BELL SYSTEM PRACTICES
Teletypewriter and Manual
Telegraph Station and PBX
Installation and Maintenance

ADDENDUM P38.322
Issue C, 8-15-47
Long Lines Department
Dist. Class. 602.05AC

WIRING DIAGRAM

NO. 19 TELETYPEWRITER SET

FIG. 4

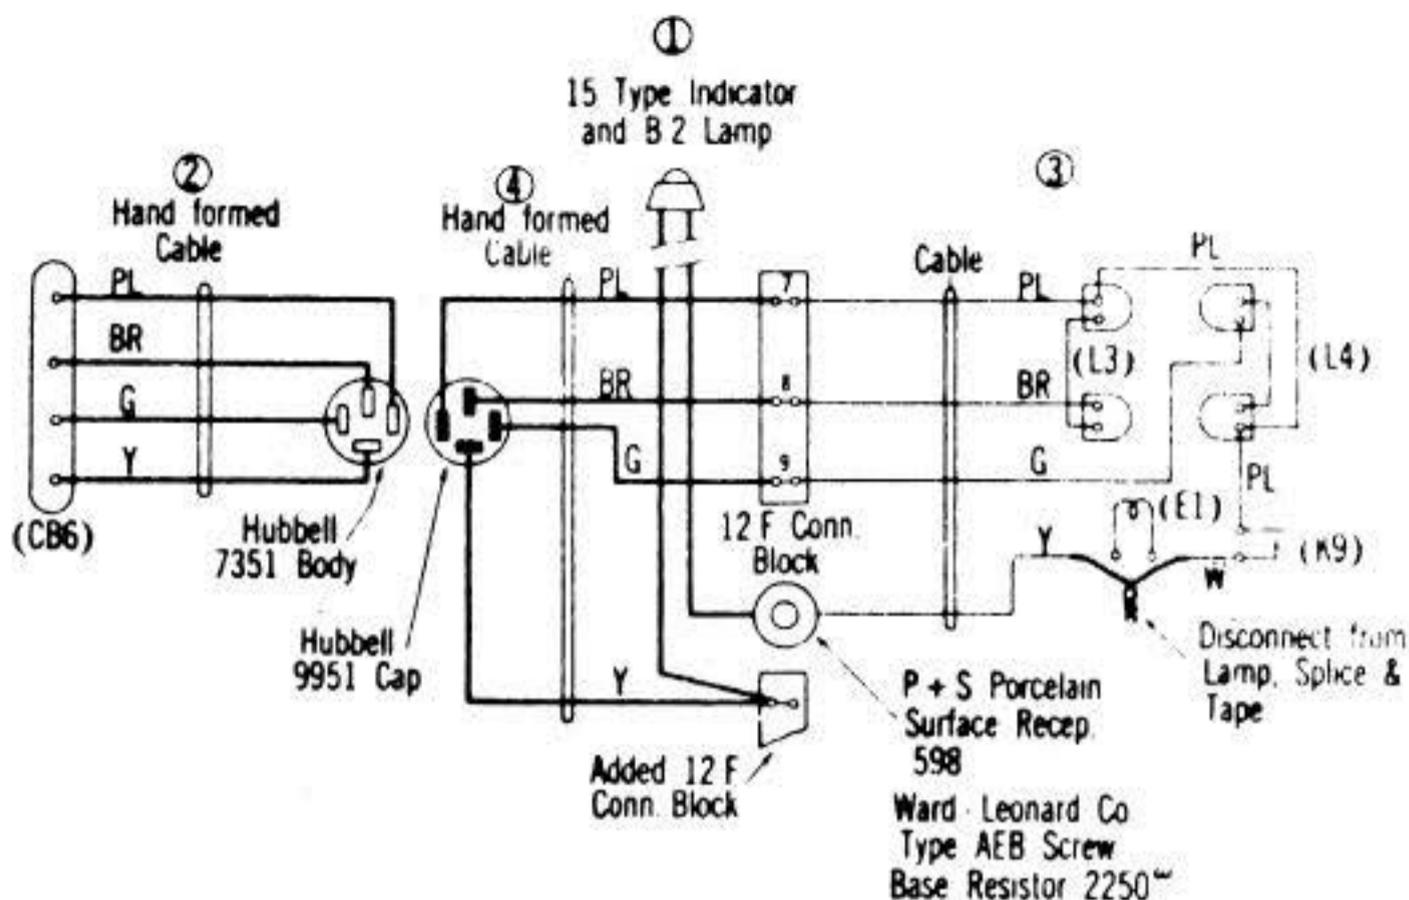
3.01 Refer to Figure 4 of this addendum. This figure shows the equipment and wiring changes required between connecting block (CB6) and the character counter and indicator lamp when the special features covered by Paragraph 1.01 (a) of this addendum are provided.

3.02 Figure 4 of this addendum also indicates a suggested relocation of the counter to another location in connection with the wiring changes referred to in Paragraph 3.01.

- ① Locate in position desired following colors available
 White 15 A 3
 Ruby 15 B 3
 Green 15 C 3
- ② Place in same position as original Cable. This shall be approximately 6 feet long
- ③ End of Line Indicator and cabling removed intact from Performator-Transmitter and relocated as in Fig A
- ④ All wire not otherwise specified to be 22 Ga. inside telephone wire
